PROJECT NAME Northern Bank Town Common Peer Review

Peer Review Comment Form

Northern Bank Proposal FBC Review

Comment #2: Facade build-out percent is insufficient

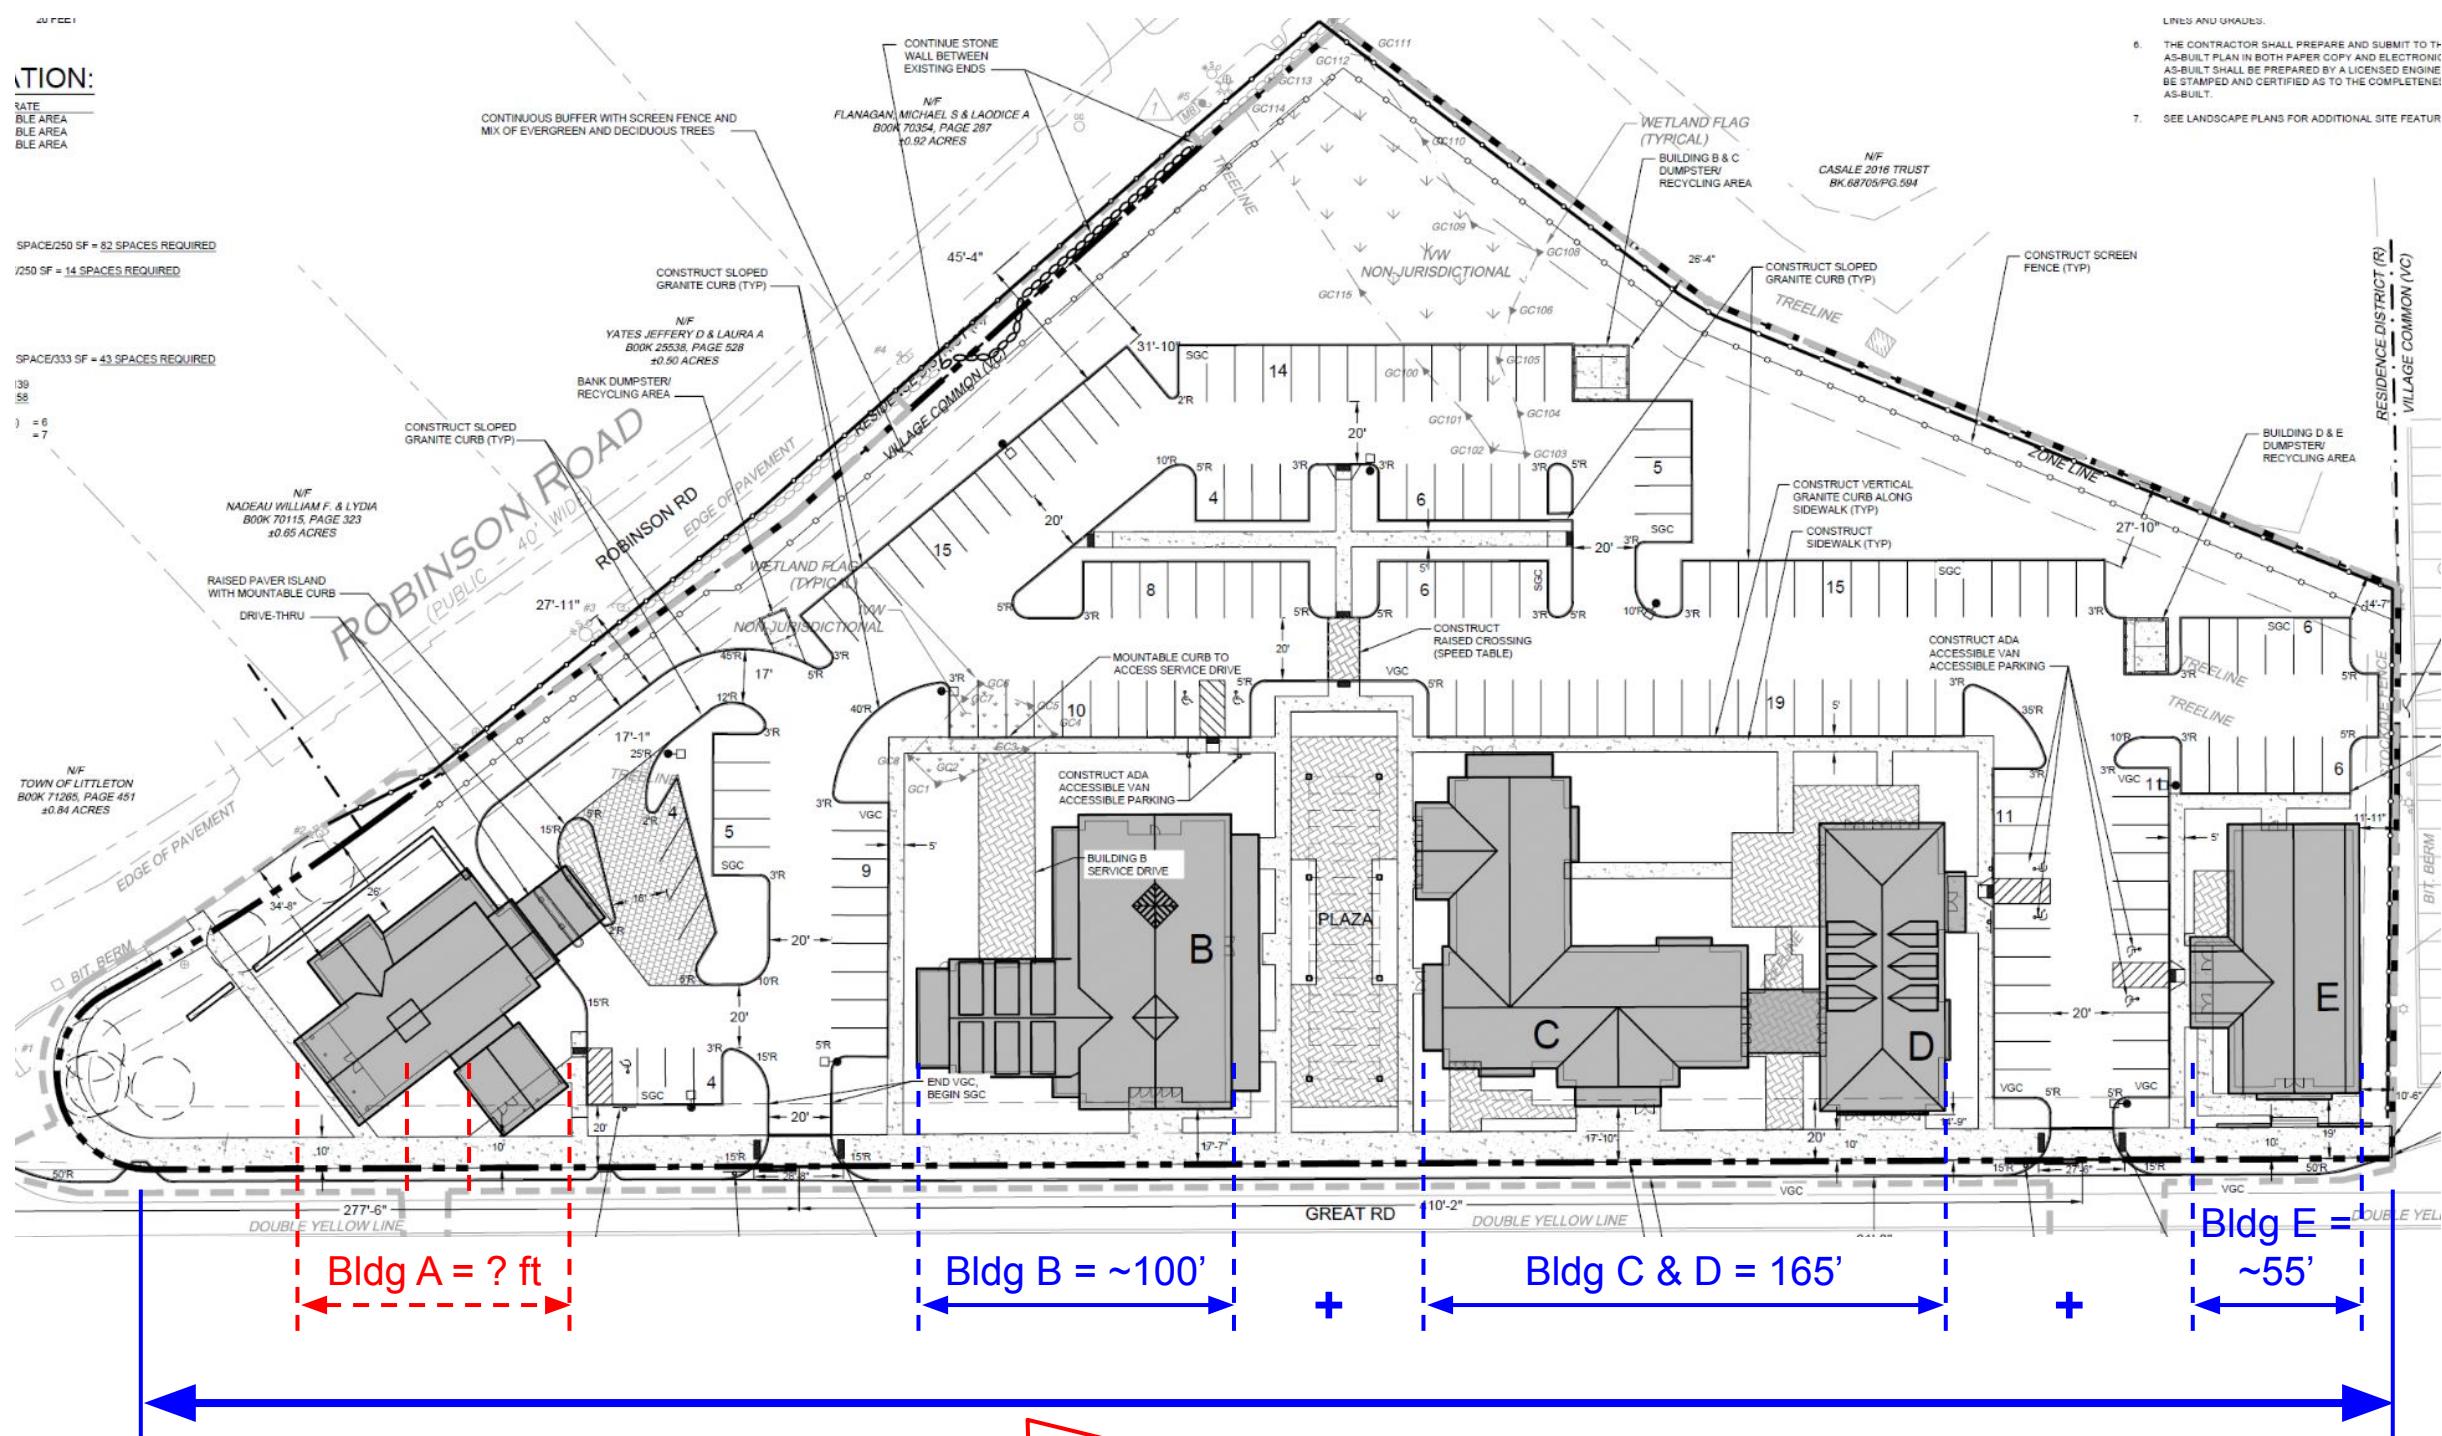
Comment #2	
Sheet No.	C-200 ("N Bank Civil and LA Updated 11-14-2022.PDF")
FBC Section	Lot Standards §173-220.A.c.
FBC Text	<i>"Building façade(s) must be built-out to a percentage of the lots width as specified in §173-220 B. Standards for all Lots."</i>
Utile Comment	Related to comment 1 above, Building A's rotation complicates the facade build-out percent calculations. Discounting this building's contribution to the facade build-out percent means that the remaining 4 buildings do not collectively meet the minimum facade build-out percent (~46% out of the minimum 60%)
Utile Recommendation	See recommendation for comment 1 above.

If discounting building A, site plan only meets ~46% out of minimum 60% build-out percent

Comment #3: Building A is not oriented toward the front lot line

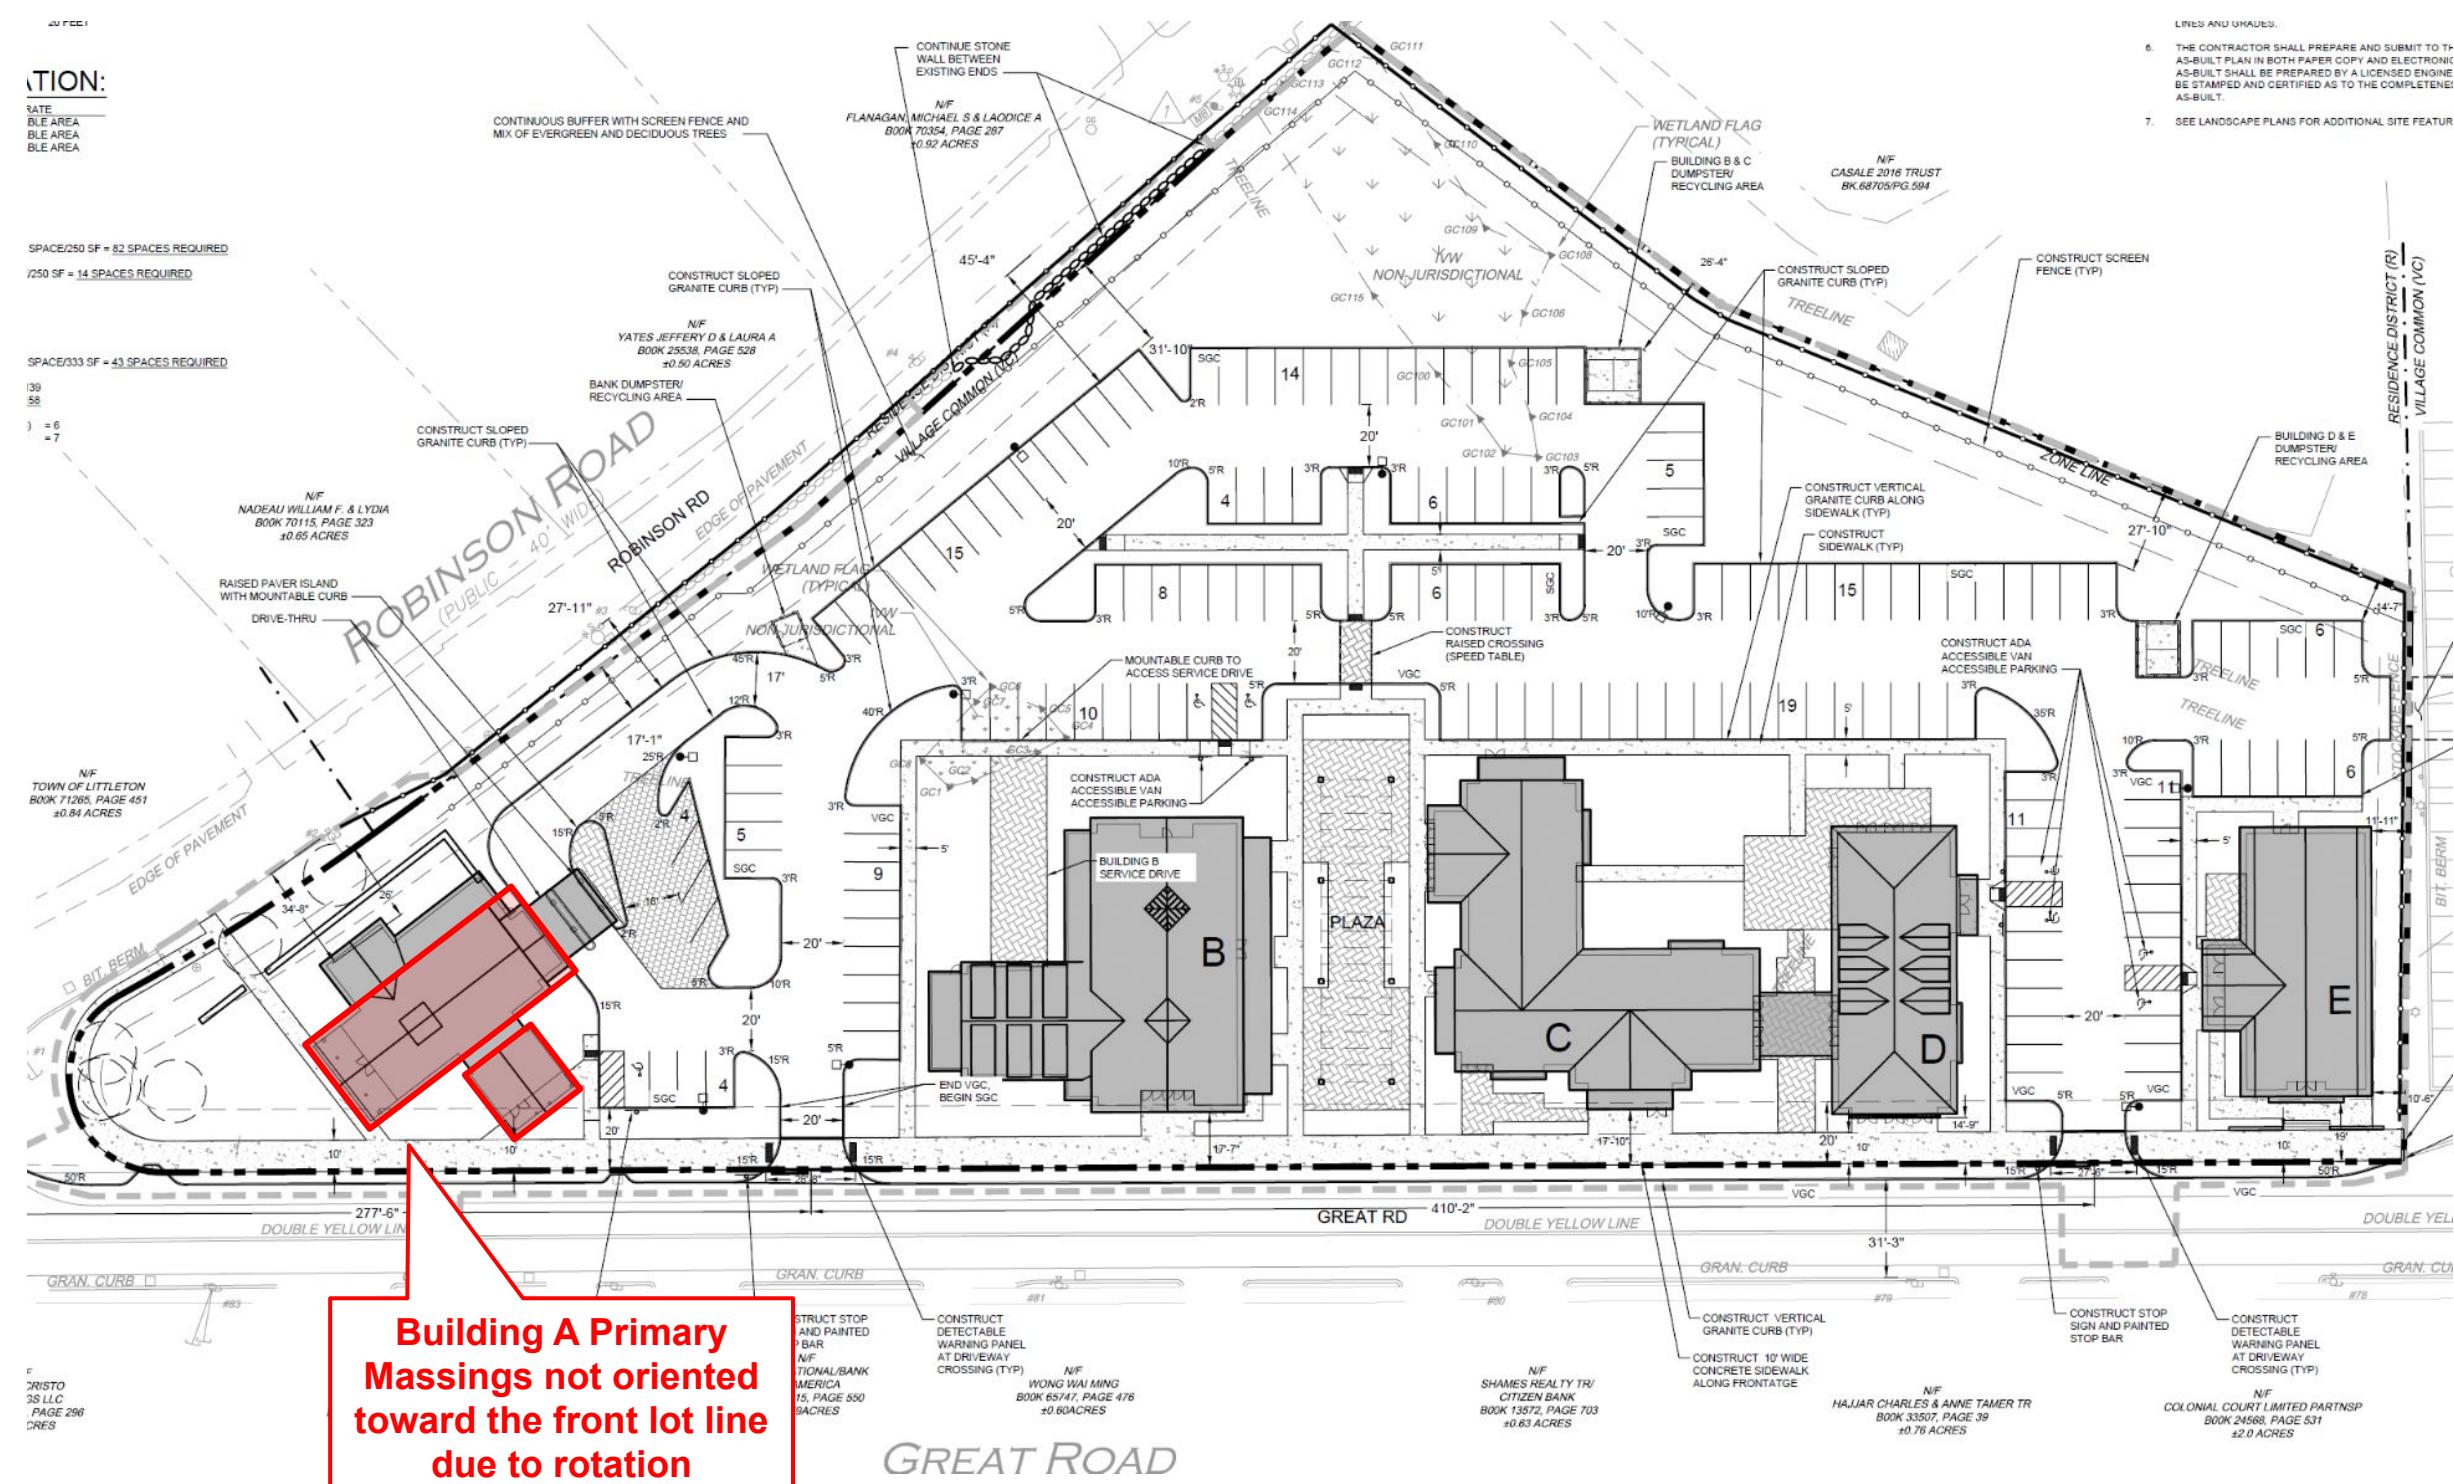
Comment #3	
Sheet No.	Building A - Floor Plan (Page 3 of "N Bank Architectural Updated 11-14-2022.PDF")
FBC Section	Building Standards §173-221.C.a.
FBC Text	<i>"The primary massing(s) of a building must be of rectangular form with a single type of pitched roof and may be oriented either with the narrow end or long side toward the front lot line."</i>
Utility Comment	Building A is rotated such that neither the Primary Massing's narrow end nor its long side are oriented toward the front lot line (along Great Rd).
Utility Recommendation	See recommendation for comment 1 above.

Comment #4: Building A primary massing is unclear & potentially too wide

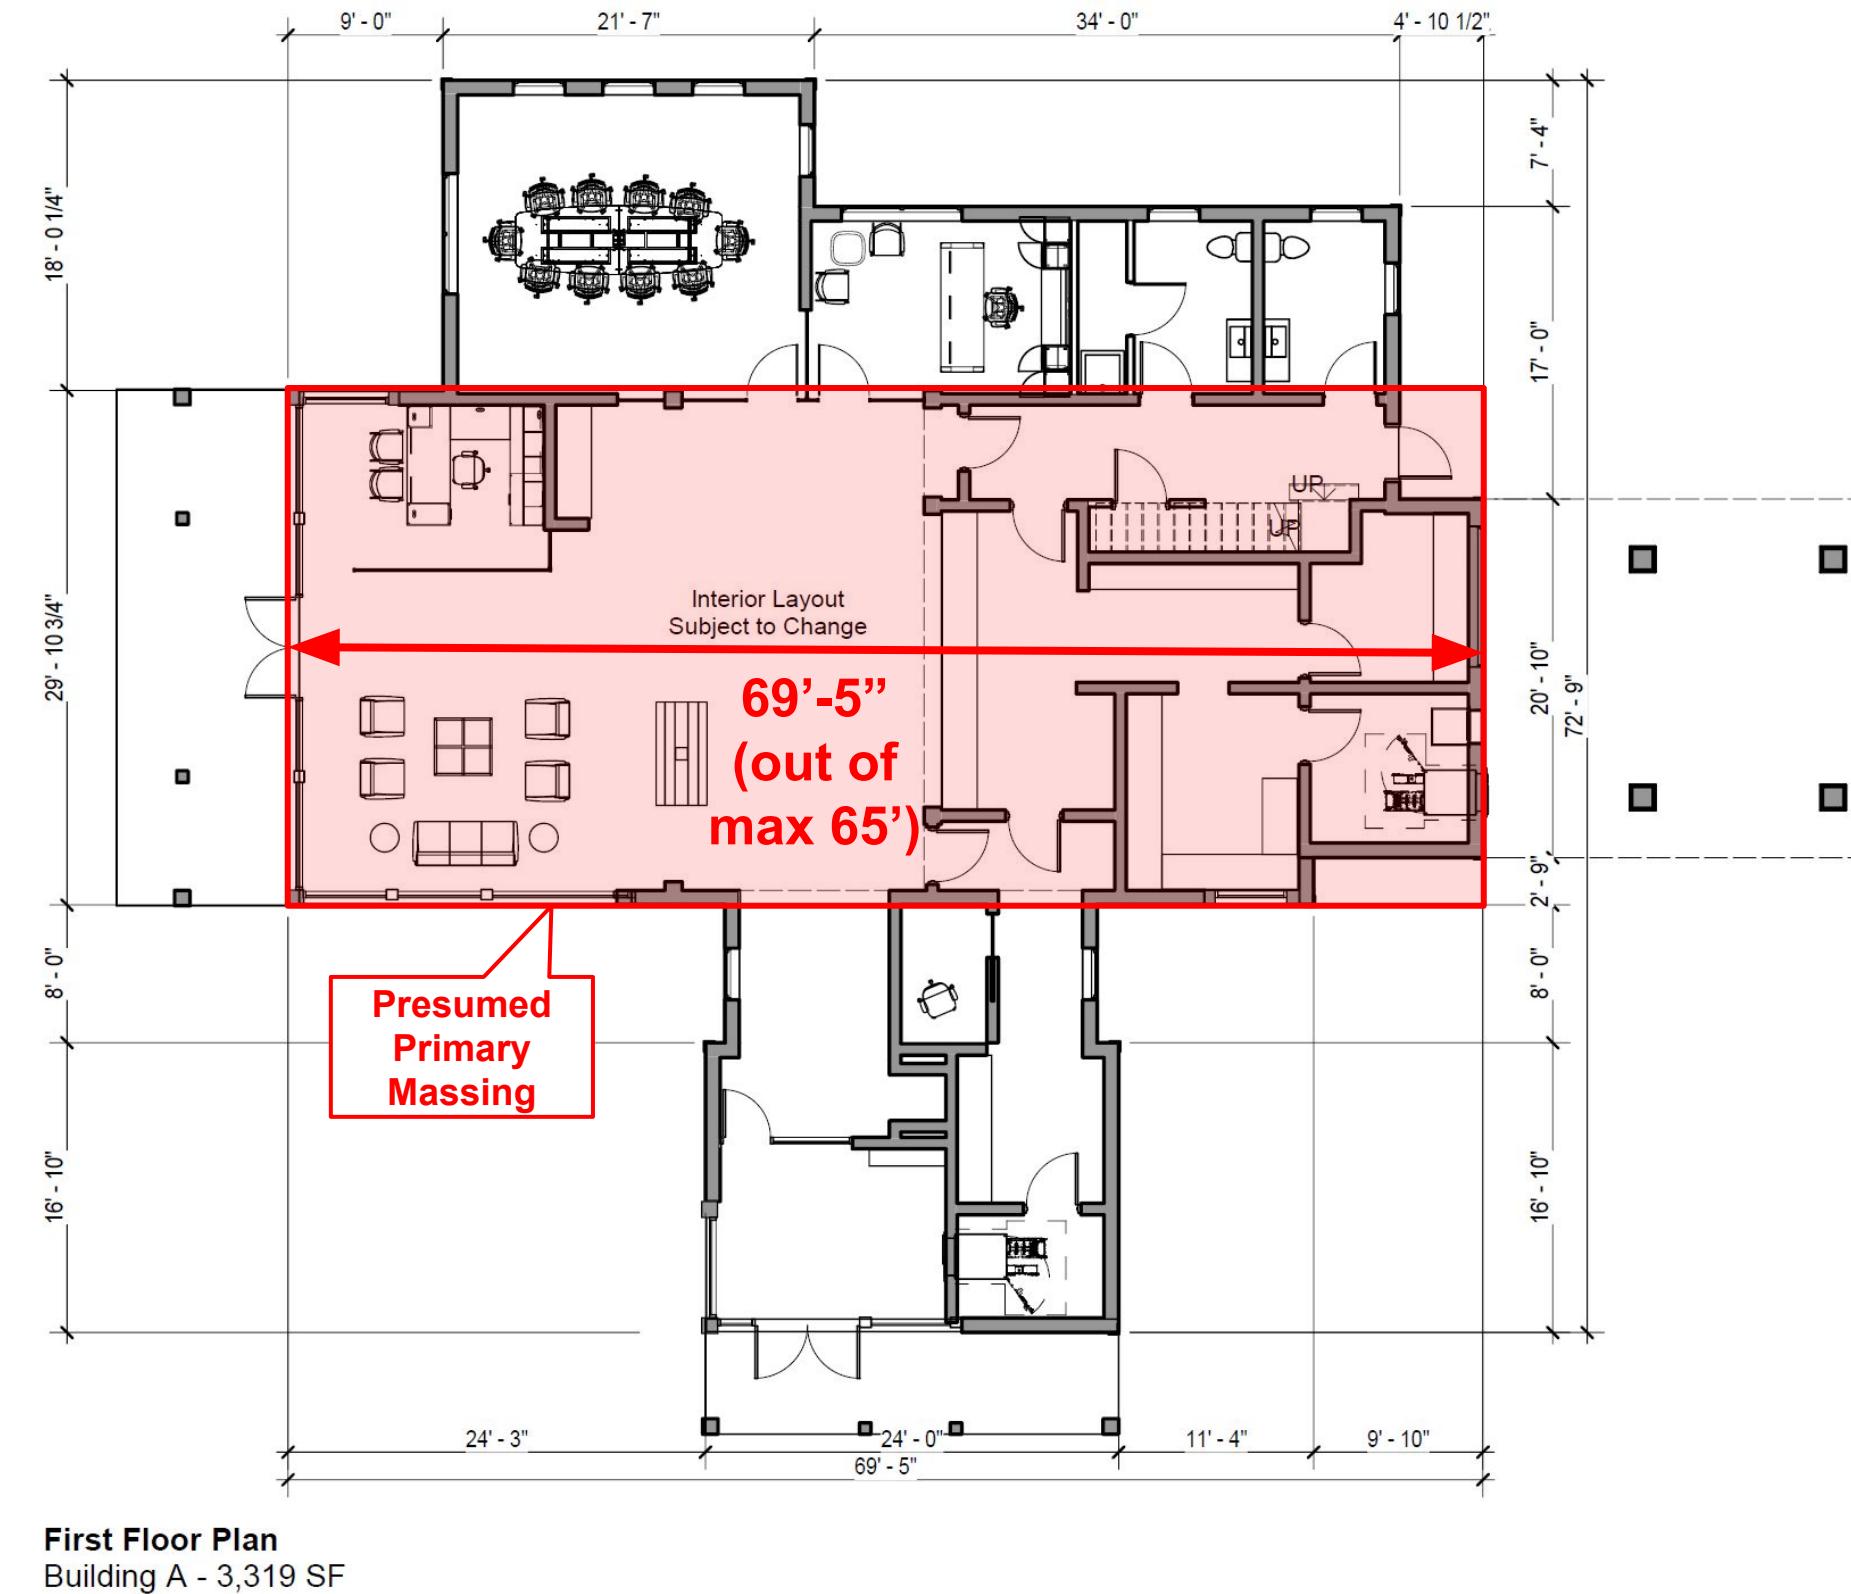
Comment #4	
Sheet No.	Building A - Floor Plan (Page 3 of "N Bank Architectural Updated 11-14-2022.PDF")
FBC Section	Building Standards §173-221.C.b and c.
FBC Text	<i>"Width of the primary massing is measured parallel to the facade, from the exterior plane of each side wall. Depth of the primary massing is measured perpendicularly from the facade as the maximum length the longest exterior side wall of a building."</i>
Utile Comment	Related to comments 1, 2, and 3 above, the rotation of Building A also complicates the measurement of the Primary Massing's dimensions (i.e., width vs depth) since it is unclear which building side is considered front vs the side. If the long side is considered oriented front, then the primary massing exceeds the maximum width (currently 69'-5" out of the maximum 65').
Utile Recommendation	See recommendation for comment 1 above.
